Subject: NO COOL AIR FROM AIR CONDITIONER (LEAK FROM EVAPORATOR)	Bulletin No: 07-005/16
	Last Issued: 12/05/2016

This bulletin supersedes the previously issued bulletin(s) listed below. The changes are noted below in Red beside the change bars.

Previously Issued TSBs:	Date(s) Issued
07-002/15	01/28/15
07-002/14	10/23/14

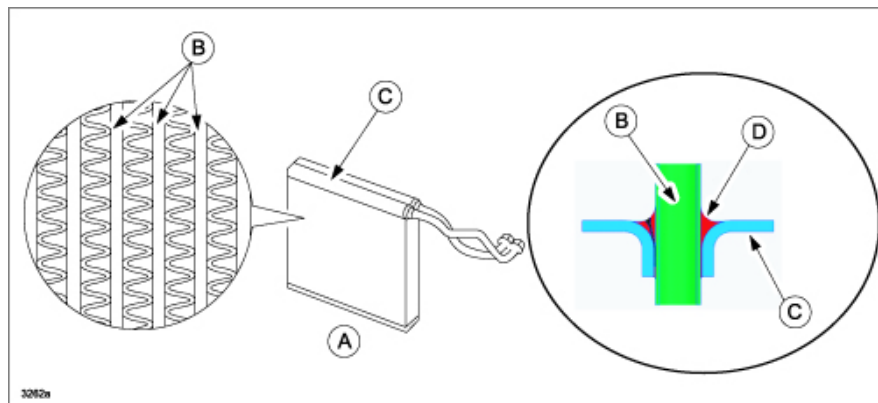
Some customers may complain about no cool air from the vents when the air conditioner (A/C) is ON. This concern may be caused by A/C refrigerant leaking from the evaporator (A) at the joint between the tubes (B) and the header (C) due to improper brazing (D). To correct the problem, the configuration of the header has been changed to improve the brazing performance in this area.
